## Technical Studies and Evaluations for the Second Injection Well Alternative at the Paradox Valley Unit

*Report from the Consultant Review Board*

Meeting, July 25-27, 2017  
Denver Federal Center  
Denver, Colorado

September 2017

**Figure I. Possible New Well Locations.**

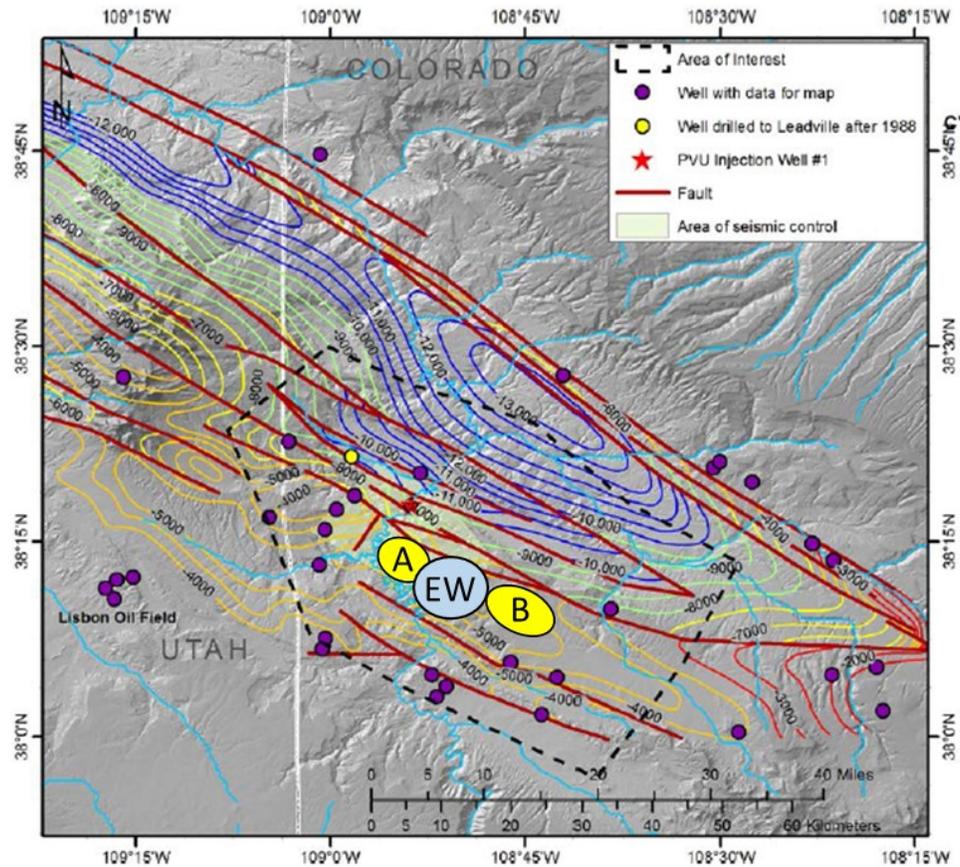
Based on available information, there are two possibly viable locations where well sites should be evaluated further as candidate sites for PVU #2. These are (see **Figure I**, Possible New Well Locations):

- A. Sites in the Dolores River Valley 1 to 2 kilometers (km) south of the current PVU #1 site. These include so-called Brine Injection Facility (BIF) surface sites as described in the deep well feasibility study (Petrotek Engineering Corporation 2017). Although not investigated as a viable candidate in the feasibility study, the abandoned Chicago wellsite adjacent to the Dolores River should also be considered as a possible surface location for the future injection well. To avoid confusion, in this report when we refer to the “Dolores River Valley sites” we include both the BIF sites and the site near the abandoned Chicago well.

- B. Sites on the Monogram Mesa, 25 to 30 km southeast of the current PVU #1 site. The deep-well feasibility study assessed two sites here, Monogram Mesa 1 and Monogram Mesa 2; however, subsequently because of environmental concerns Monogram Mesa 2 was removed from consideration as a viable site .

The Dolores River Valley sites are considered higher risk because their long offsets require drilling through the boundary fault and at an angle. These sites are also geographically close to clusters of earthquakes associated with the PVU #1 well. However, because of their proximity to the PVU #1 well site, the surface/logistical advantages of these sites are substantial. These advantages may mitigate the higher subsurface risks, which can be evaluated pending some additional modeling work to estimate pressurization near the boundary fault (see Recommendations #10 and #12), and by investigations assessing the impact of drilling horizontally farther away from the fault to reach a more desirable injection location (3D seismic survey; drilling exploratory wells; modeling salt rheology; see Recommendations #3, #4, and #7).

The Monogram Mesa I site is ranked highest with respect to drilling considerations (well-bore can be near-vertical) and subsurface characterization (site is far from the boundary fault, and far from PVU #1 and the associated pressurization of the Leadville Formation). Also, Monogram Mesa I is situated near the middle of the reservoir compartment, in a location that has been virtually aseismic up to the present. However, Monogram Mesa I has less desirable surface characteristics; surface access is difficult and developing the site requires installing a long pressurized pipeline from the brine production wells in Paradox Valley. It is also possible that the Monogram Mesa I site is close to a salt weld; this can be evaluated by a 3D seismic survey and by drilling an exploratory well (see Recommendations #3 and #4).

Since the southern new fault block is large and there are two possibly viable sites within it (A and B in **Figure 1**), a “regional-scale” seismic survey should be performed even before drilling an exploratory well (see Recommendation #4). This regional-scale survey would need to cover 60 square miles or more to encompass both possibly viable sites. Such a 3D seismic survey would be costly, but could be designed with a sparse grid of shots and receivers appropriate for elucidating structural detail, although lacking the resolution necessary for detailed reservoir characterization.

We recommend undertaking an engineering design study of specific surface and bottom hole locations for the two proposed sites for PVU #2 (A and B in **Figure I**). This study would evaluate surface location issues as well as downhole trajectory concerns, i.e., how wellbore orientation relative to the tectonic stress field affects wellbore instability and directional drilling risk. Also, the study should consider wellbore trajectory shape, considering various types of slant, “S,” deep “J,” or even double-build horizontal geometries if completion techniques warrant this. The study should consider needs for specific wellbore orientations through any salt section as well as in the target formation.

**Figure 2. Seismic Stations and Seismicity.**

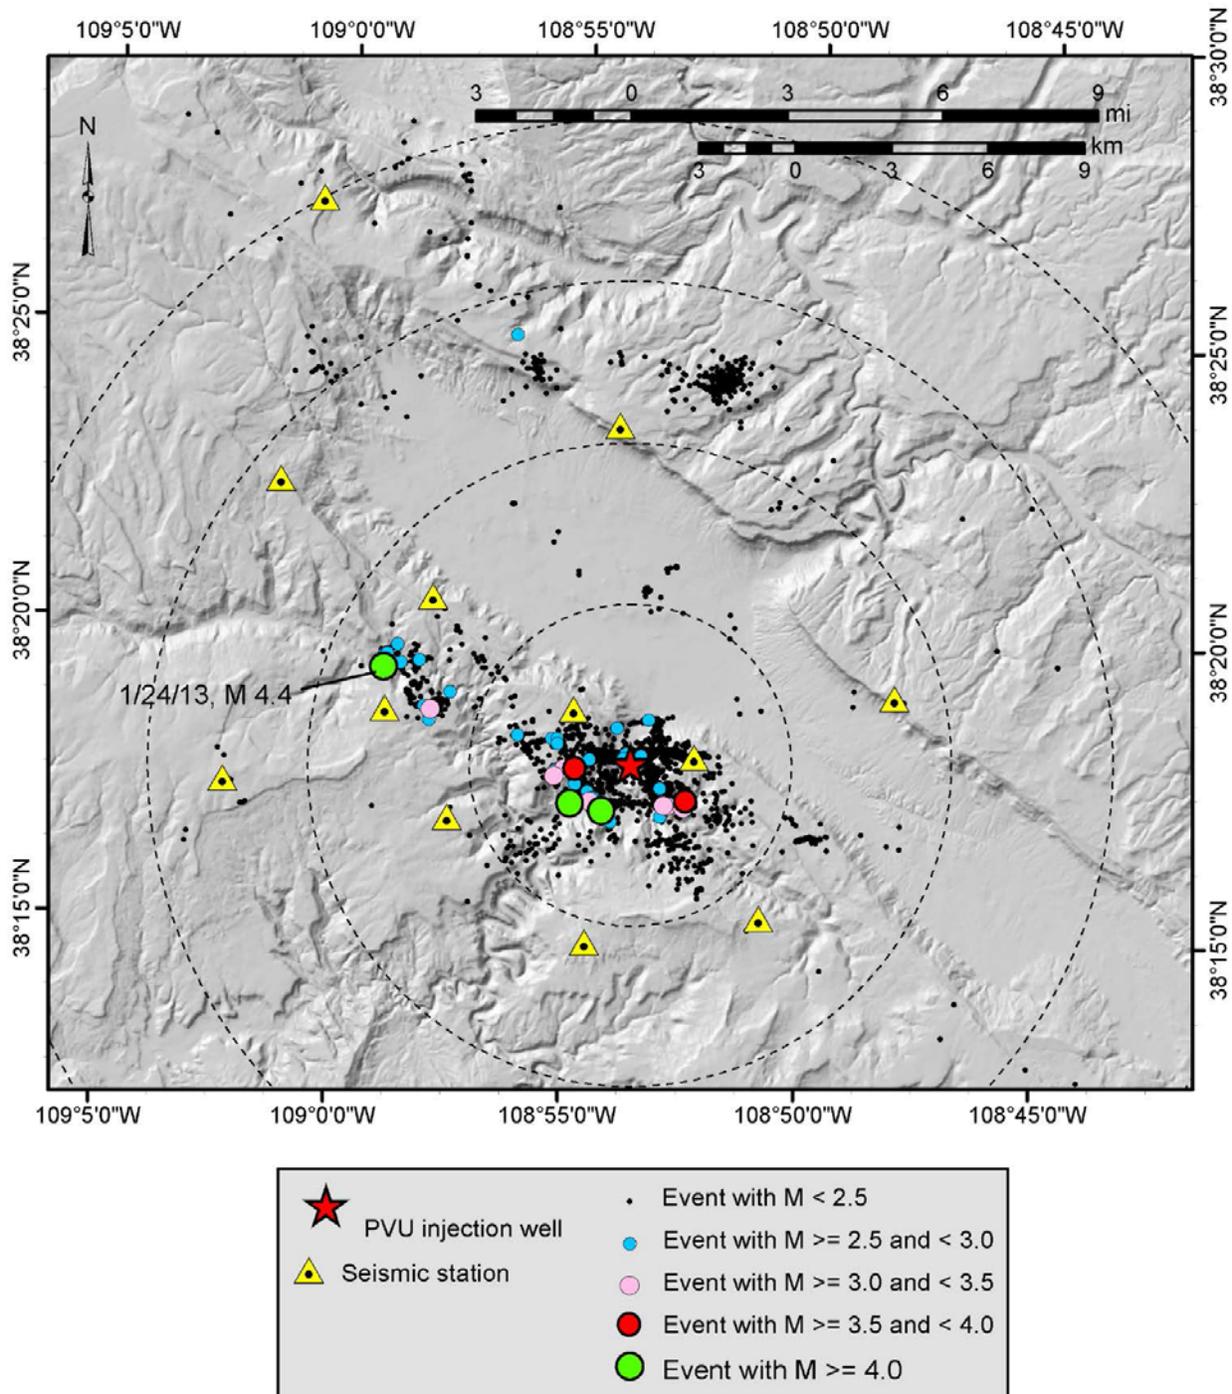
When the PVU #2 site is chosen, we presume it is desirable to locate nearby earthquakes with an accuracy comparable to that provided by the current PVU seismic network (**Figure 2**, Seismic Stations and Seismicity). If the second injection site is close to the PVU #1 well (within a few km; e.g., one of the Dolores River Valley sites), it may be unnecessary to install additional seismic stations prior to completing the new well (see **Figure 2**). However, if the second injection site is more than five km from the PVU #1 wellsite (e.g., on Monogram Mesa), installing at least three or more new seismic stations is essential, and even more are highly desirable.

**Figure 3. Regional Faulting and Seismicity.**

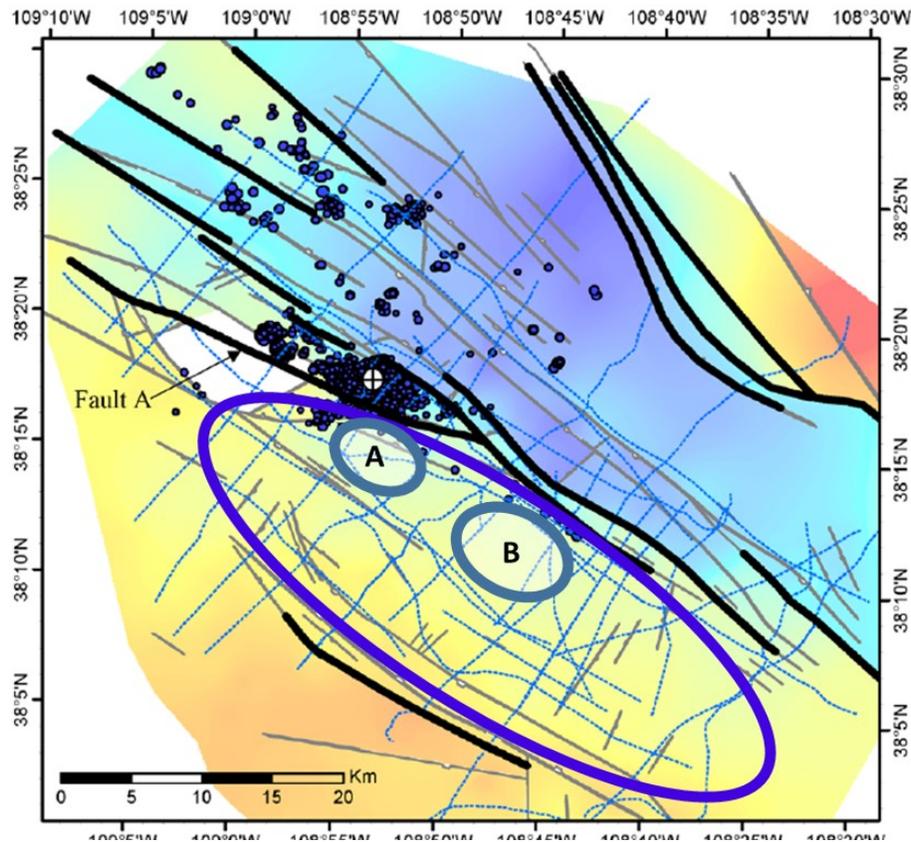
This exploratory well should penetrate to the base of the sediments. The proposed PVU #2 injection targets in the Leadville Formation are all situated within the large fault-bounded “new fault block” that has these characteristics (see **Figure 3**, Regional Faulting and Seismicity.):

- It appears not to have any internal faults with a significant vertical offset that could lead to a sealing condition (i.e., all have less than the 500 ft offset criterion mentioned by the geological experts; see Detournay and Dzik 2017). Internal compartmentalization of the new fault block could reduce the well life for PVU #2.

- The strata are generally flat-lying, having dips close to zero.
- The block appears to be separated by at least one sealing fault and one partially sealing fault from the current PVU #1 injection location in the Leadville Formation, and from the reservoir blocks that take the PVU #1 injection volumes.

- Within this new fault block there has been no detected induced seismicity associated with the current injection at PVU #1. This provides support for the assertion that the fault (or faults) to the northeast of areas A and B are truly sealing, or indicates that critically stressed faults are not present in this area.

If the PVU #2 well is drilled into the new fault block near either sites A or B in **Figure 1**, the reservoir formations that will be pressurized by brine injection are compartments of the Leadville Formation located south of a supposedly sealing boundary fault (designated as Fault A in **Figure 3**) situated just to the

Based on the 2D seismic interpretation (**Figure 3**), there is reasonable confidence that the spatial extent of the reservoir in the new fault block is not locally compartmentalized. Although the 2D survey provides a reasonable preliminary basis for targeting this block for PVU #2 injection, further investigation is needed in the form of a 3D seismic survey at the preferred site, first at a coarse scale and then with subsequent refinement (Recommendation #3).

**Figure 4. Radial Step-out VSP Characteristics.**

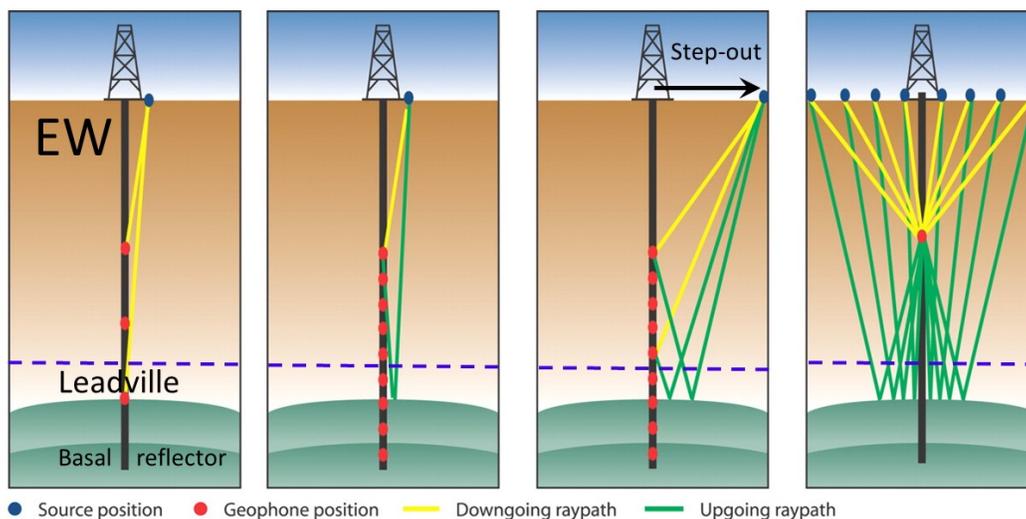
The VSP profile should be developed along a radius (or multiple radii) from the wellhead using seismic excitation sites at the surface, with a recording string of geophones within the borehole (**Figure 4, Radial Step-out VSP Characteristics.**). The surface excitation sites (if vibroseis is utilized) are stepped out from the wellhead at pre-designed spacings in a radial direction to create an aperture within which acoustic properties and seismic stratigraphy are determined. The multiple pathways and shorter travel distances associated with VSP profiling, combined with its precise constraints on depth, can greatly improve the interpretation of existing seismic data and any 3D seismic surveys taken in the future (see Recommendation #3). Better velocity information will also improve accuracy of past and future earthquake locations. Hence, the VSP data provide another method to reduce risk.

**Figure 5. Pressure vs Time at PVU #1.**

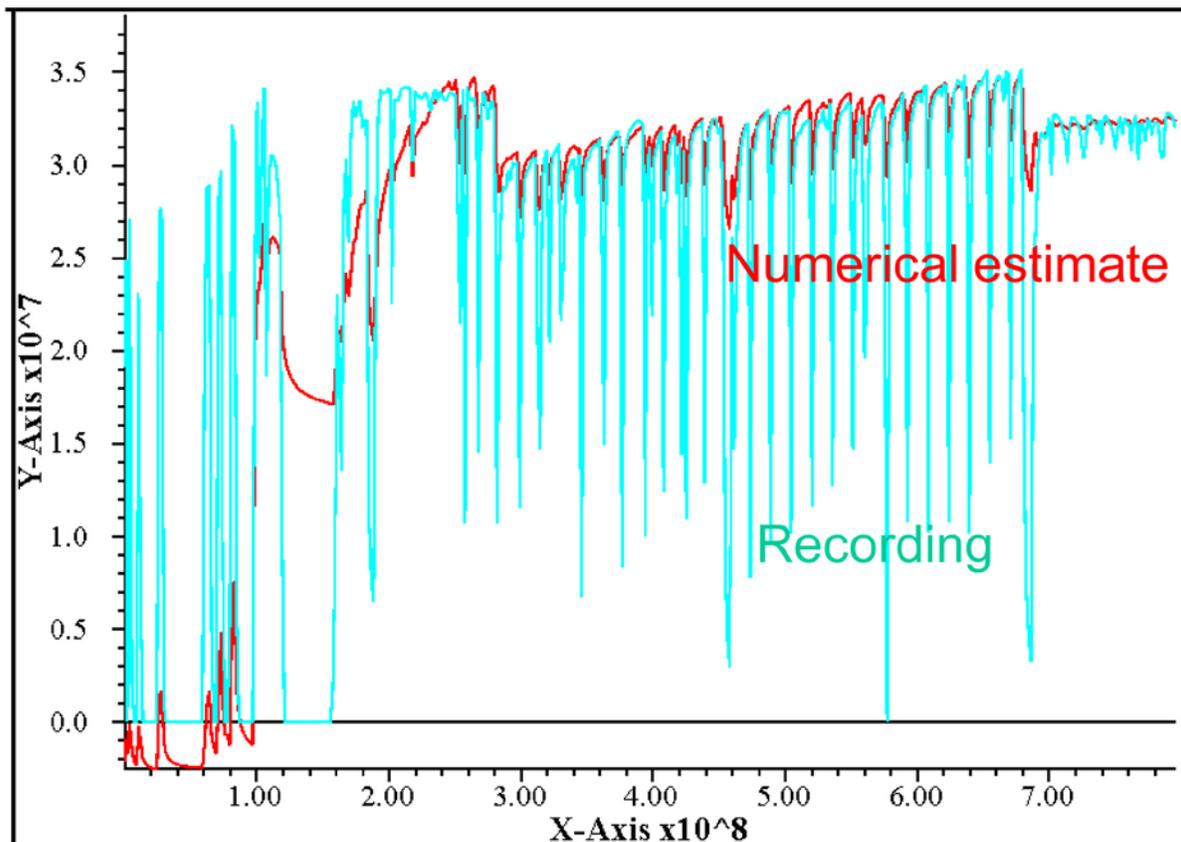
There remains, however, significant uncertainty concerning the values of the permeability/mobility. The only direct measurements available to estimate the permeability are the surface injection pressures measured at PVU #1. Numerical simulations using a large-scale model (covering 22 years and 40 km X 56 km x 7.5 km) are able to match the observed pressure from about 2000 to the present by adjusting the permeability and assuming the impermeability of the faults with more than 500 ft offset (see **Figure 5**, Pressure vs Time at PVU #1).

However, the injection pressure measured during the period from the start of the injection to 1999 is not well matched by that model. This inconsistency provides an opportunity to obtain additional information about the global permeability and the topology of the reservoir in a region around PVU#1 at a “medium” scale ranging from hundreds of meters to kilometers. This analysis will also provide information on how skin or diffusivity changes with time. The analysis now available suggests that permeability near the well increases significantly over time due to pore pressure increase, cooling, and/or chemical reactions.
